<b>Title - Sujet</b> Dragage Cap-aux-Meules Dragage havre et chenal Cap-aux-Meules	
<b>Solicitation No. - N° de l'invitation</b> EE517-220734/A	<b>Amendment No. - N° modif.</b> 002
<b>Client Reference No. - N° de référence du client</b> R.082054.100	<b>Date</b> 2021-07-28
<b>GETS Reference No. - N° de référence de SEAG</b> PW-\$QCM-034-18195	
<b>File No. - N° de dossier</b> QCM-1-44047 (034)	<b>CCC No./N° CCC - FMS No./N° VME</b>
<b>Solicitation Closes - L'invitation prend fin</b> <b>at - à 02:00 PM</b> Eastern Daylight Saving Time EDT <b>on - le 2021-08-17</b> Heure Avancée de l'Est HAE	
<b>F.O.B. - F.A.B.</b> Specified Herein - Précisé dans les présentes	
<b>Plant-Usine:</b> <input type="checkbox"/> <b>Destination:</b> <input type="checkbox"/> <b>Other-Autre:</b> <input checked="" type="checkbox"/>	
<b>Address Enquiries to: - Adresser toutes questions à:</b> Kirouac, Jennifer	<b>Buyer Id - Id de l'acheteur</b> qcm034

## Dredging of harbor and channel, Cap-Aux-Meules

### Amendment 002

**STATIONS D'ÉCHANTILLONNAGE  
 CHENAL**

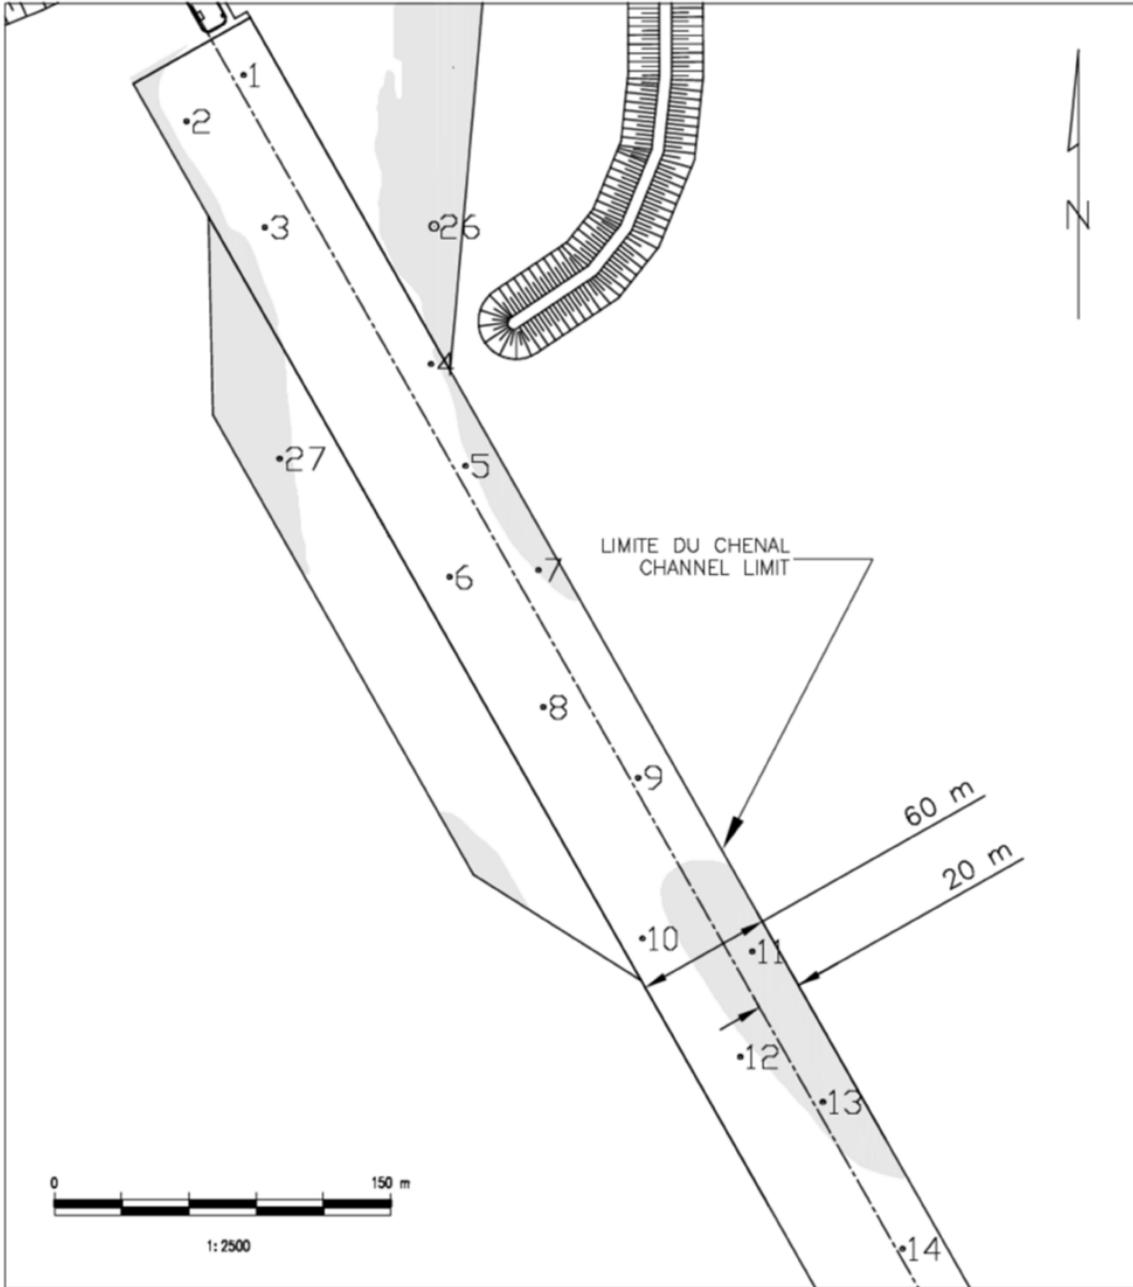
In the technical specifications in section 35 20 24, page 11, paragraph 1.11.2: We refer to appendix B. 2 pages are missing which are illegible in this appendix. Also, the localization of the samples is non-existent. Can you provide them?

In the technical specifications in section 35 20 24, page 14, paragraph 1.14.4: Can you provide the locations of the sediment samples referred to in this paragraph?

**Answer:** See Annex B.

**Answer:** See Annex B.

Delete Annex B from the Specifications and replace by the following :
